PCB CHANGE ATRLM080 to ATRLM088

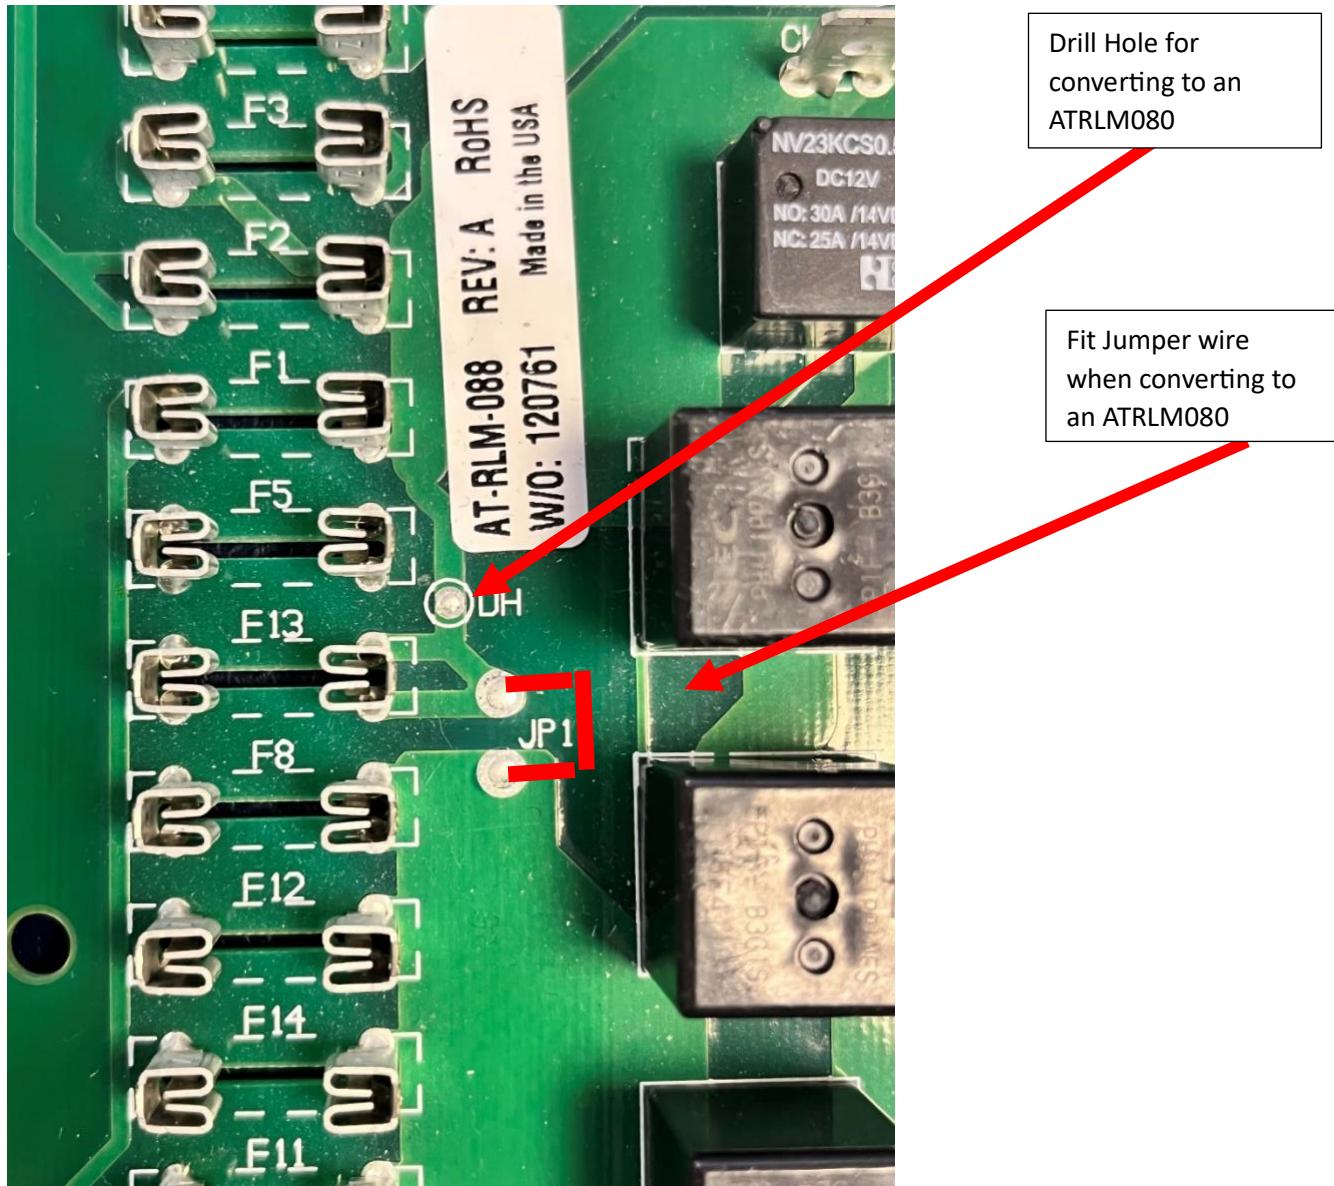
When replacing the ATRLM080 PCB with ATRLM088 on certain models of caravans no modifications are required and it is a direct replacement, but due to the 88 pcb having an additional fuse they may be misaligned to the current labelling.

- 1) if the vehicle has a Truma Combi or an Alde system then no modifications are required.
- 2) Double check this by checking the plugging on the harness, if pin J3'2 is unpopulated (see fig 1) then no modifications is required.

If a whale system is installed and pin J3'2 is populated, then modifications to the PCB is required (see fig 2)

If this modification needs to be done this can be done at BCA.
